CHANGE ORDER

<h1>CHANGE ORDER</h1>	CHANGE ORDER NUMBER
	1
	8/12/2024
	Page 2 of 2

36TH AVE W & 35TH AVE W
164TH ST. SW TO 148TH ST. SW
STA 98+50 TO 103+00
UTILITY INFORMATION PLAN

REFERENCE SHEET NO. AW11 SHEET 1 OF 14 SHEETS

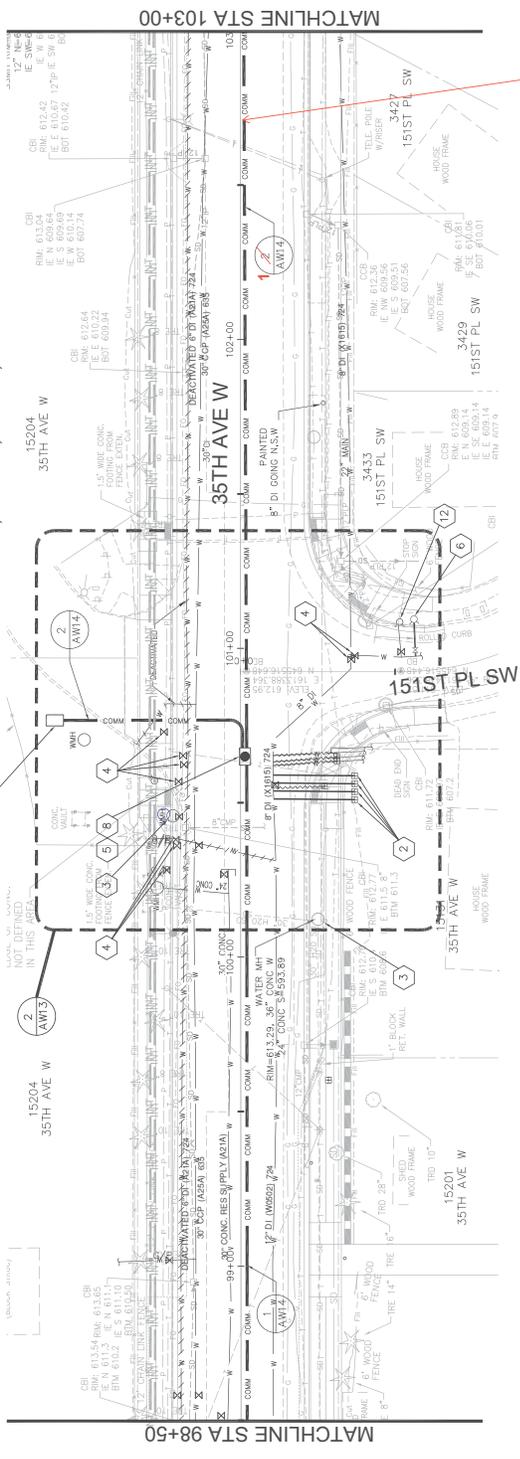
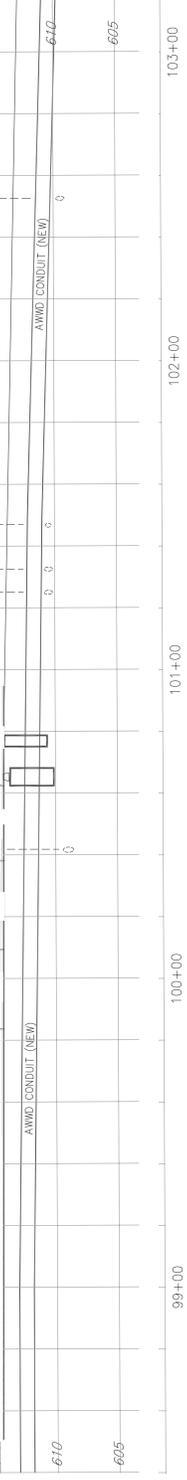
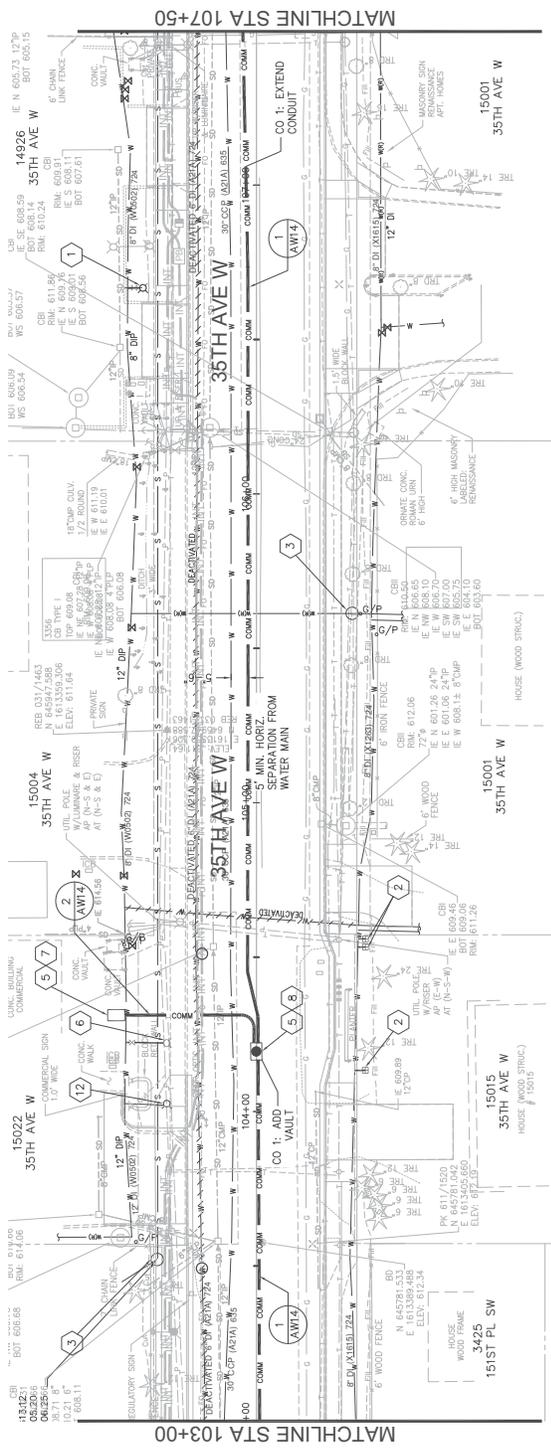
This Change Order compensates the Contractor for added work to construct an extension of the AWWD Communication Duct bank as shown on the revised attached plan sheets AW11-AW12 with revisions dated 9/19/24. This duct bank will begin at 151st Pl SW and continue north to their new Operations Center Headquarters at 14807 Hwy 99 S.

CO 1, Triple Conduit here instead of single

RCO #1	Unit	Original QTY	New QTY	Delta
AWWD Single Conduit Duct Bank	LF	610	270	-340
AWWD Triple Conduit Duct Bank	LF	2000	2770	770
AWWD Conduit Pull Box	EACH	3	3	0
AWWD Conduit Junction Box	EACH	6	7	1
Bank Run Gravel for Trench Backfill	TON	6100	6400	300
HMA for Pavement Repair, Cl. 1/2 in. PG 58H-22	TON	870	920	50

- Increase item #36 "Bank Run Gravel for Trench Backfill" in the amount of 300 Tons.
- Decrease item #49 "AWWD Single Conduit Duct Bank" in the amount of 340 LF.
- Increase item #50 "AWWD Triple Conduit Duct Bank" in the amount of 770 LF.
- Increase item #51 "AWWD Junction Box" in the amount of 2 EA.
- Increase item #65 "HMA for Pavement Repair CL. ½ In. PG 58H-22" in the amount of 50 Tons.
- Increase item #176 "Class II Disposal Premium Type B" in the amount of 450 Tons.
- Increase item #180 "Class II Disposal Premium Type C AWWD" in the amount of 200 Tons.
- Add new item #182 "Removing Asphalt Concrete Pavement" in the amount of 200 Square Yards.
- Add new item #183 "Removal of AWWD Temporary Gravel Trench Patch" in the amount of 200 Square Yards.
- Add new item #184 "Sawcutting" in the amount of 880 LF.

REFERENCE SHEET NO. AW06

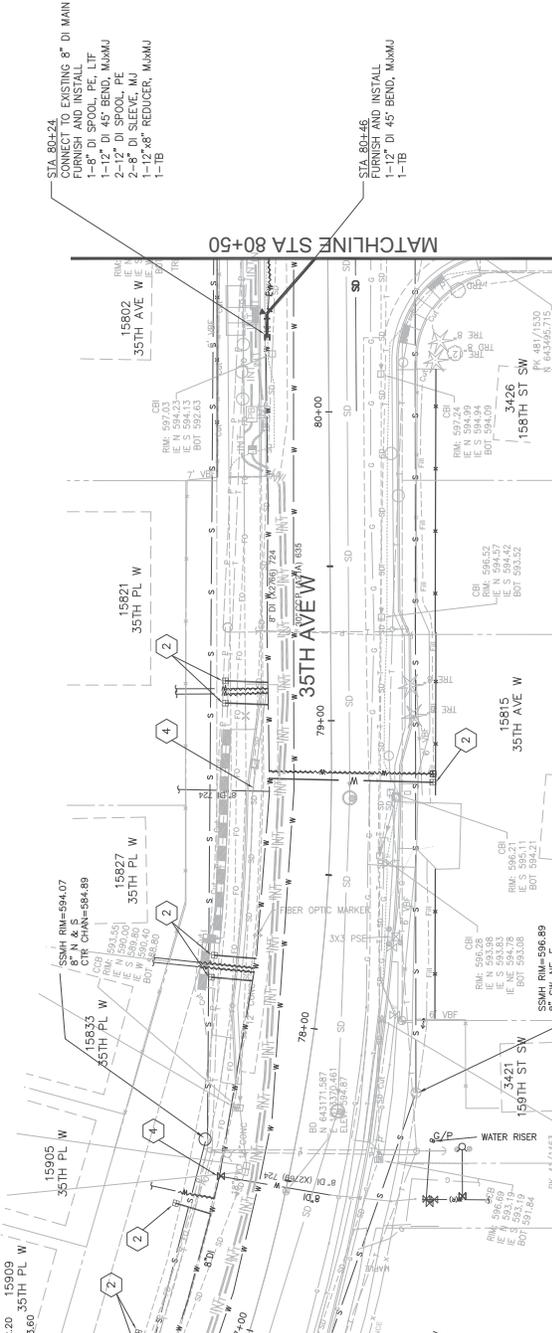
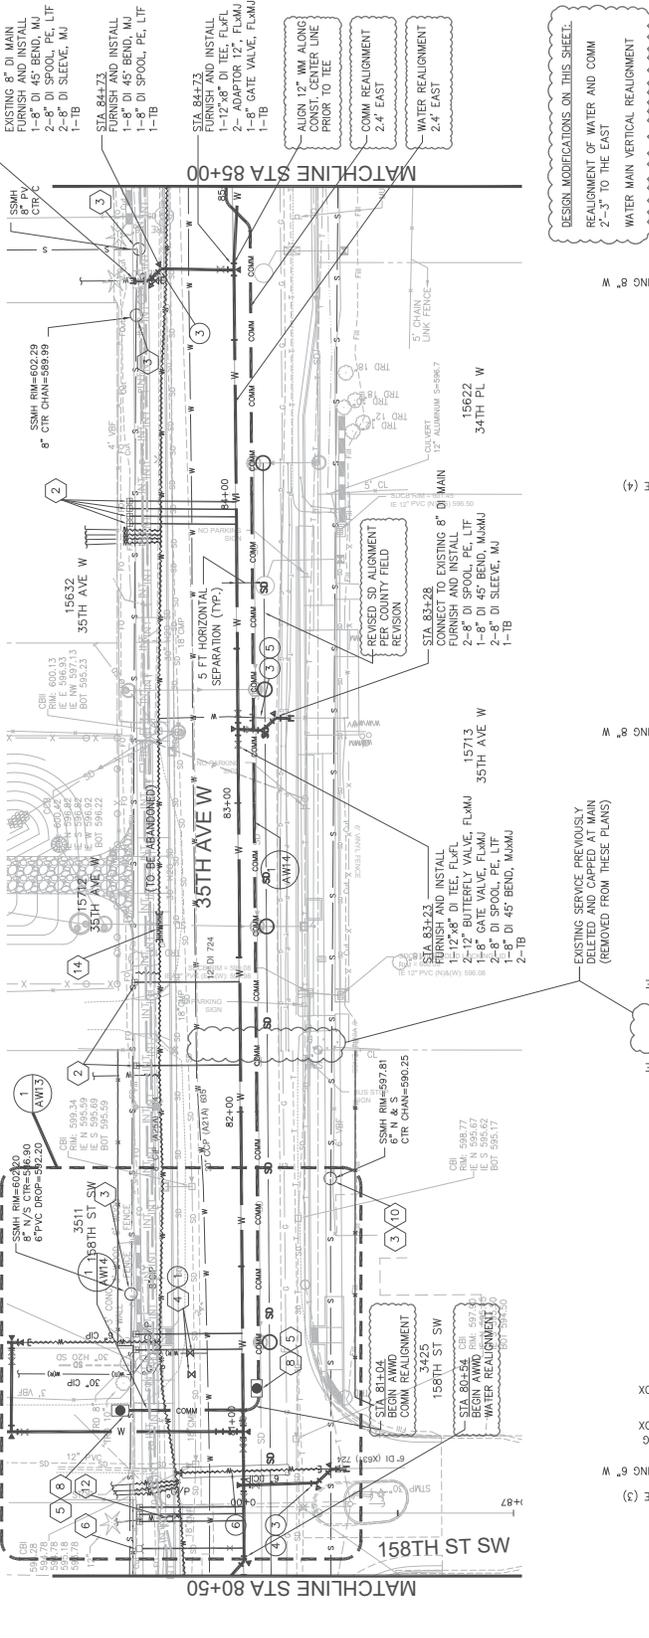
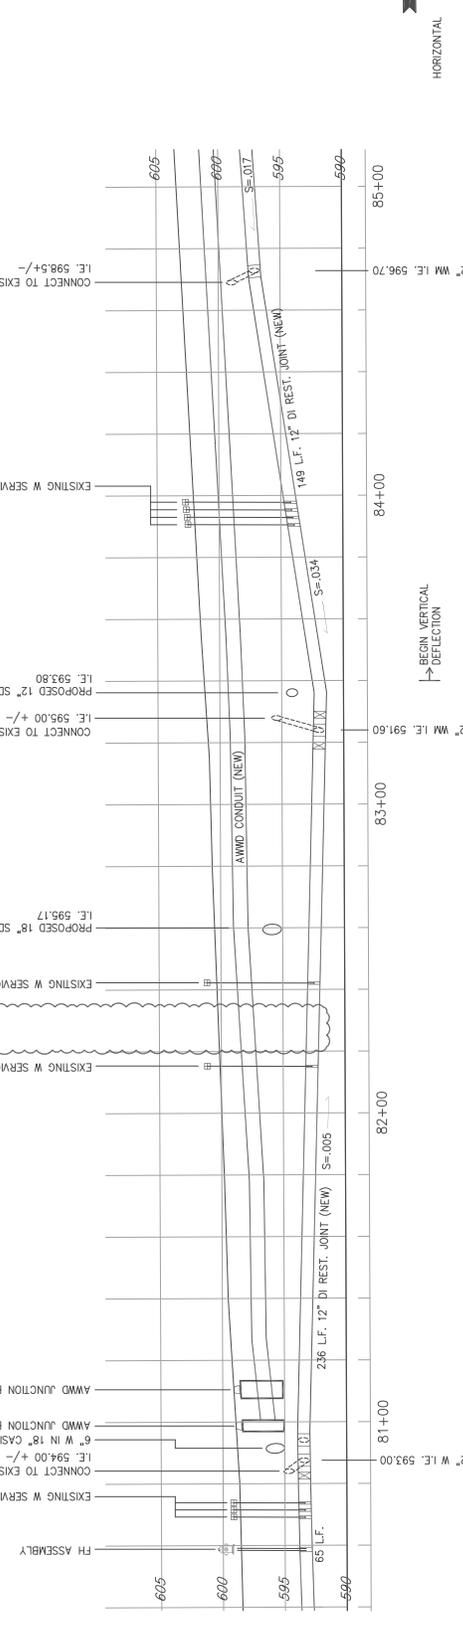
This change order compensates the Contractor for added costs associated with shifting the water main to the east as shown on revised attached AWWD plan sheets AW05, AW06, AW07, and AW13 with revisions dated 9/19/24.

- Increase item #182 "Removing Asphalt Conc. Pavement" in the amount of 130 square yards.
- Increase item #183 "Removal of AWWD Temporary Gravel Trench Patch" in the amount of 60 square yards.
- Increase item #184 "Sawcutting" in the amount of 660 linear feet.
- Add new item #185 "HMA for Temp. Patch Cl. ½ In. PG 58H-22" in the amount of 10 tons.
- Add new item #186 "Water Main Alignment Revision" in the lump sum amount of \$57,363.

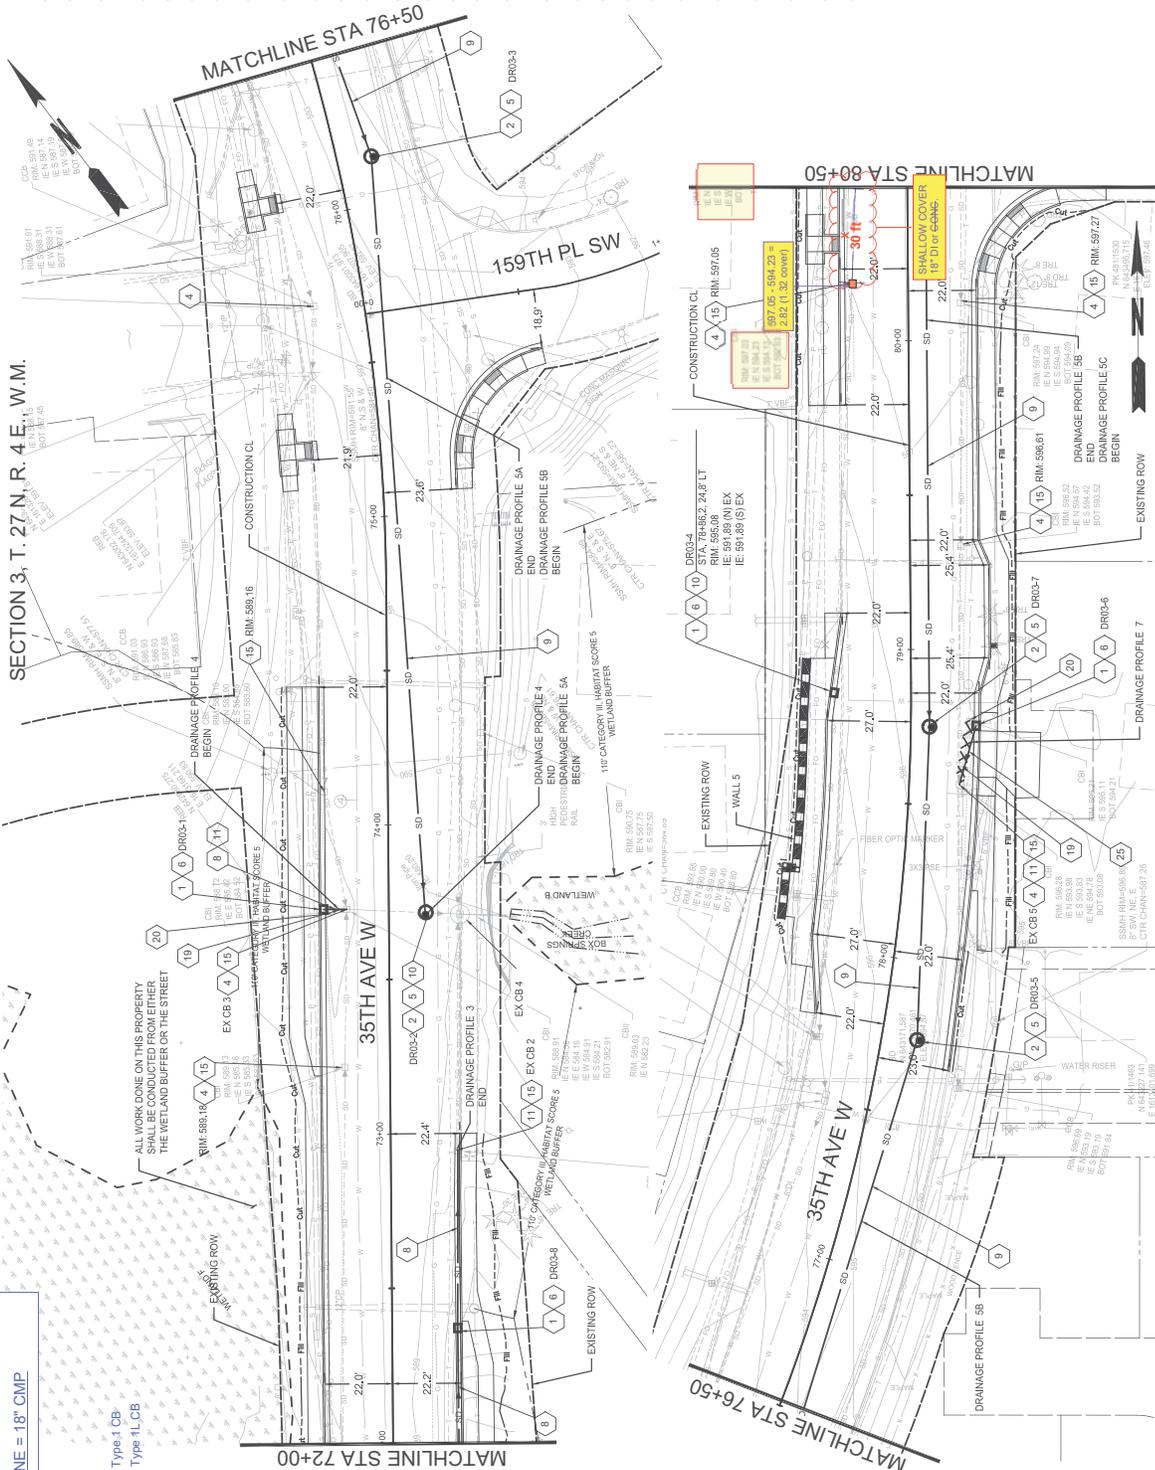
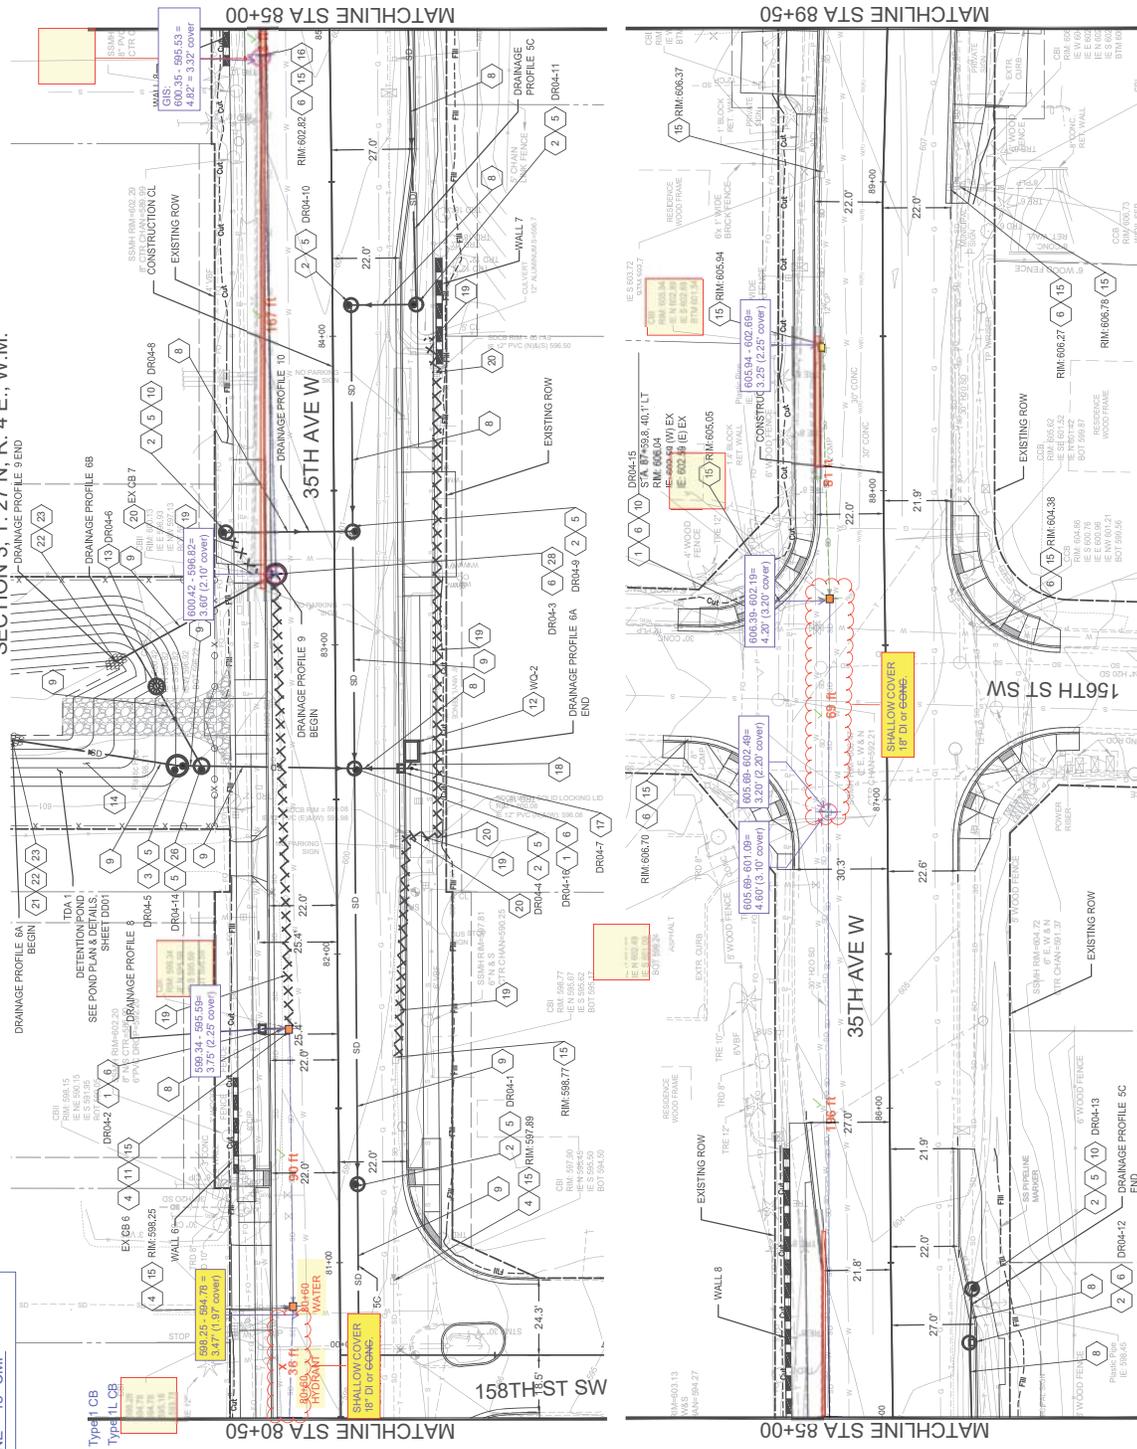
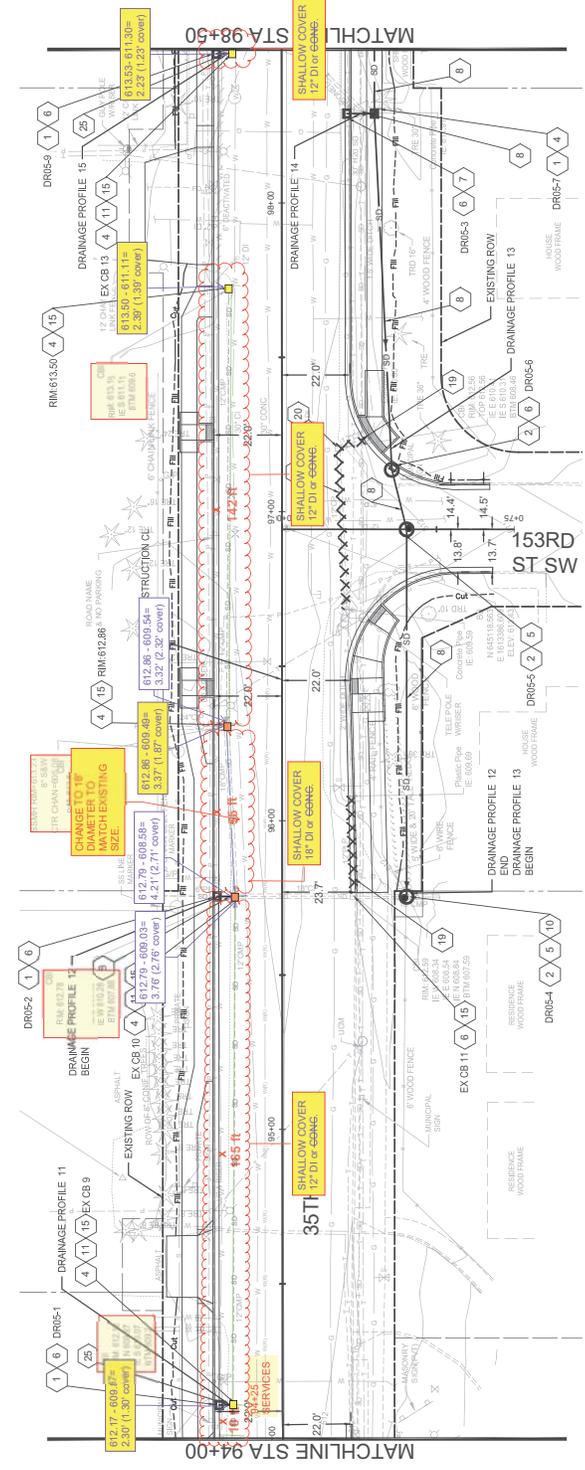
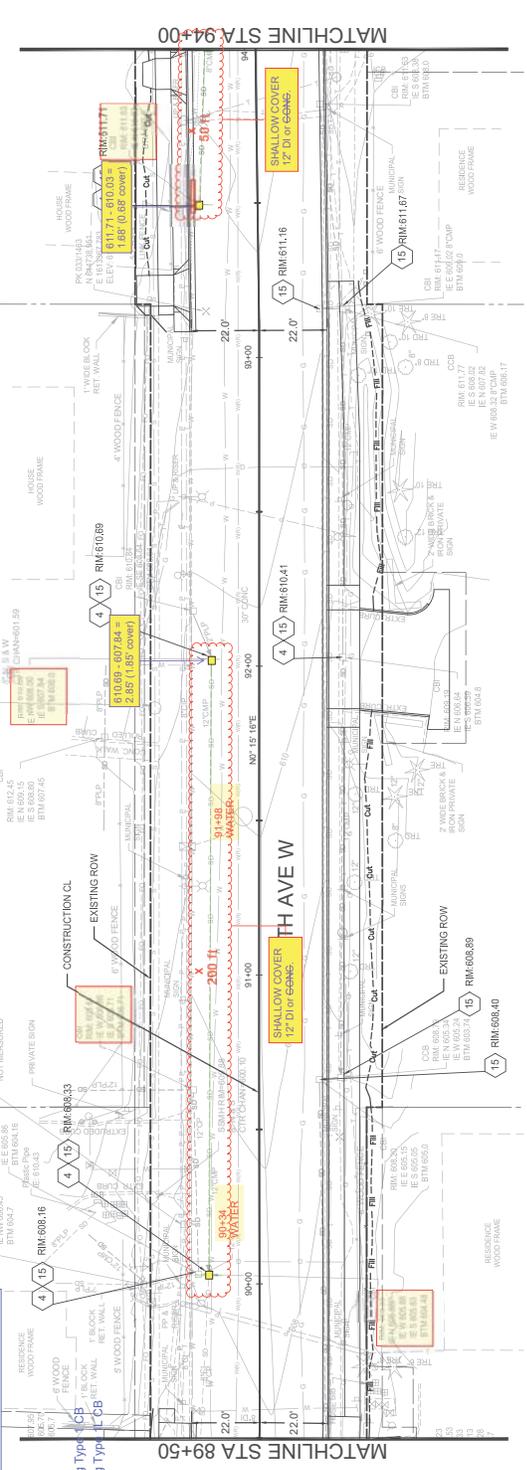
This Change Order compensates the Contractor for removing and replacing existing storm drainage pipe runs and catch basins from Station 88+00 to 94+00 and as identified on revised plan sheets DR03 through DR05. Prior to removal, the Contractor shall record existing rim and invert at existing catch basins and reinstall the new storm drainage to match the existing invert elevations and pipe run slopes.

Existing GREEN LINE = 12" CMP
 Existing BLUE LINE = 18" CMP

Ductile Replacement

Existing GREEN LINE = 12" CMP
Existing BLUE LINE = 18" CMP

Ductile Replacement
 = Replace Existing Type
 = Replace Existing Type
 MAINTAIN EXISTING REFERENCED PIPE AND STRUCTURES

Removing Drainage Structure and Removing Existing Pipe includes the removal and disposal of catch basins and storm drain pipes where new catch basins and pipes are shown on the revised plan sheets DR03 through DR05, or where designated by the Engineer.
